**Meeting:** 5/21/2026  
**Applicant:** Charity Honeycutt  
**Owner:** Charity Honeycutt

**Location:** 1520 Fremont Place **Parcel ID:** 81 L E 045  
**District:** Old North Knoxville H  
**Zoning:** RN-2 (Single-Family Residential Neighborhood)  
**Description:** Folk Victorian with Craftsman and Colonial Revival influences, c.1915

**5-G-26-HZ**  
**APPLICATION FOR CERTIFICATE OF APPROPRIATENESS**

1520 Fremont Place 37917  
 Old North Knoxville H

1 X 6 Hardy Trim  
1 X 2 Hardy Trim  
1 X 4 Hardy Trim

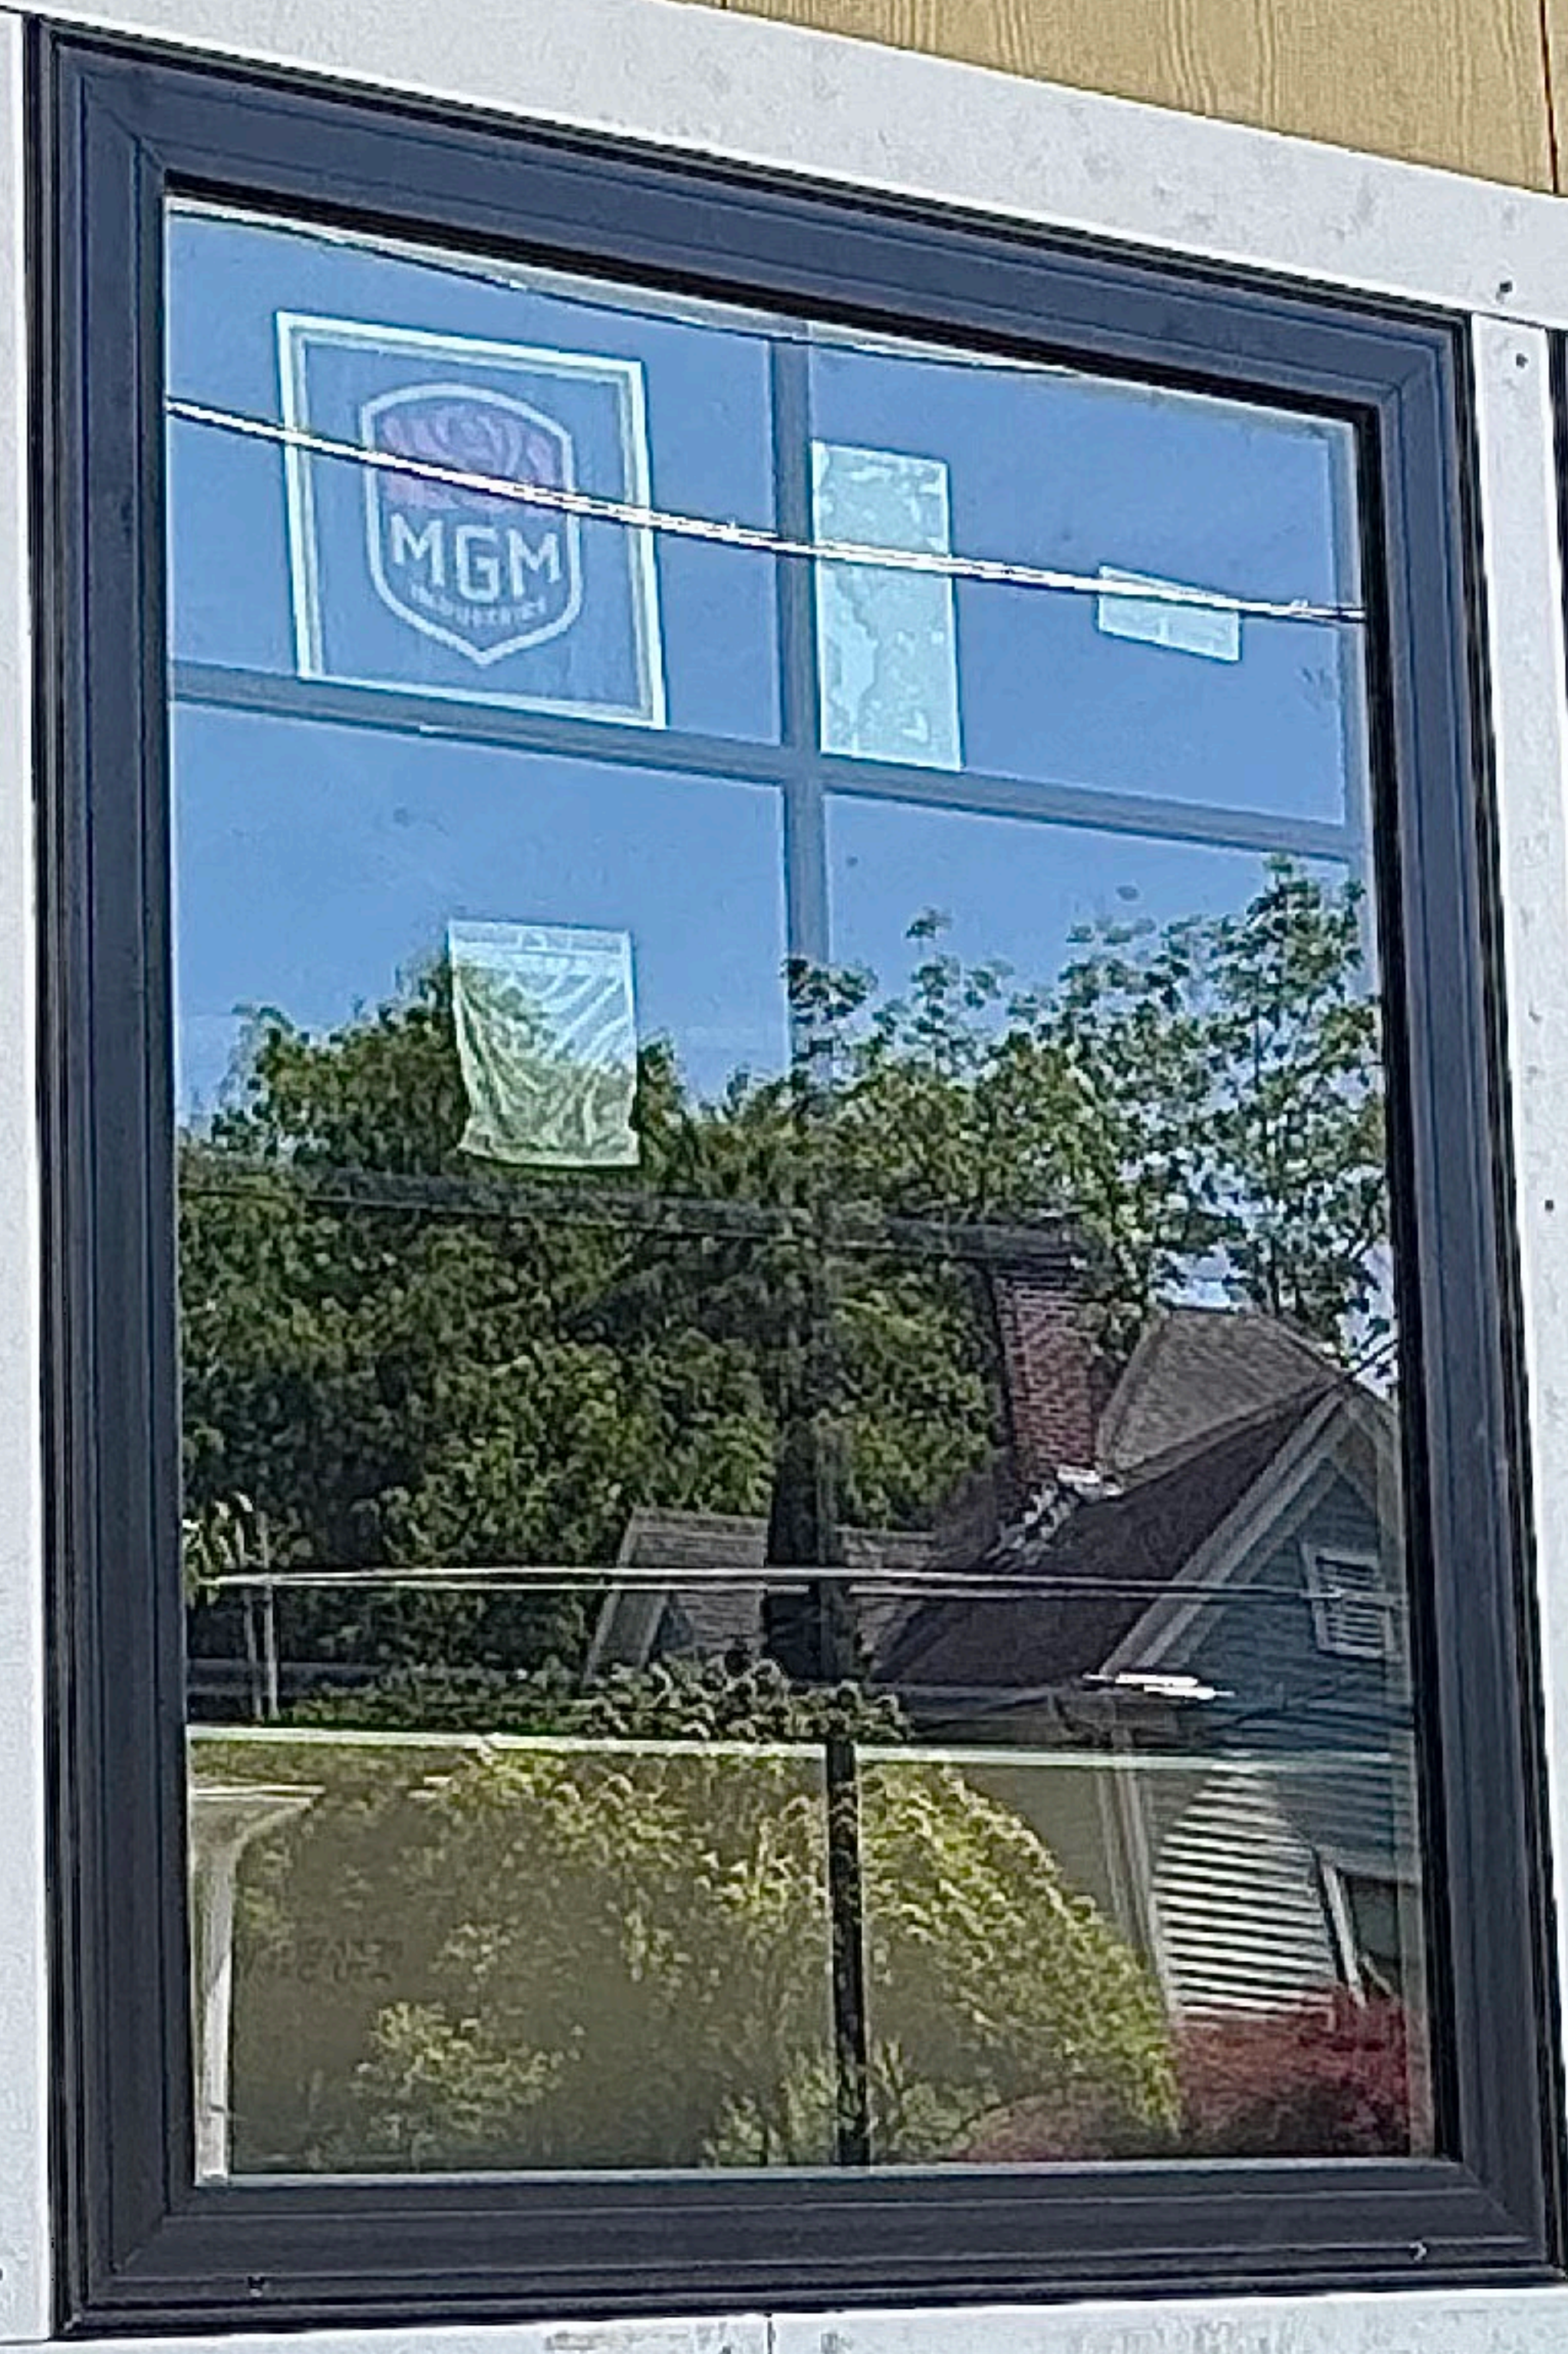
5. The proposed window trim is fiber cement, with a 1x2 header, 1x4 casing, and a 1x6 projecting sill. While proposing fiber cement trim may be appropriate for a house clad in asbestos shingles with fiber cement patching, the trim does not reflect the design of the original trim that was removed. 4" flat casing is wider than the original, and the 1x6 projecting sill will be disproportionate to the windows. A revised specification could include 2" casing, smaller headers, and a smaller sill, and should be submitted to staff for approval. Trim boards should also be applied between adjoining windows to reflect the original trim's depth and dimension.

- 1) pane division on new windows on right side and rear elevation to reflect pane division of original windows;
  - 2) window trim to be revised to better reflect the historic trim's design and size, and trim to be installed between adjoining windows, with final specifications submitted to staff for approval;
  - 3) window trim to be applied to windows on all elevations;
  - 4) revised window schedule to be submitted to staff for approval, showing specific proposed locations of each window.
-
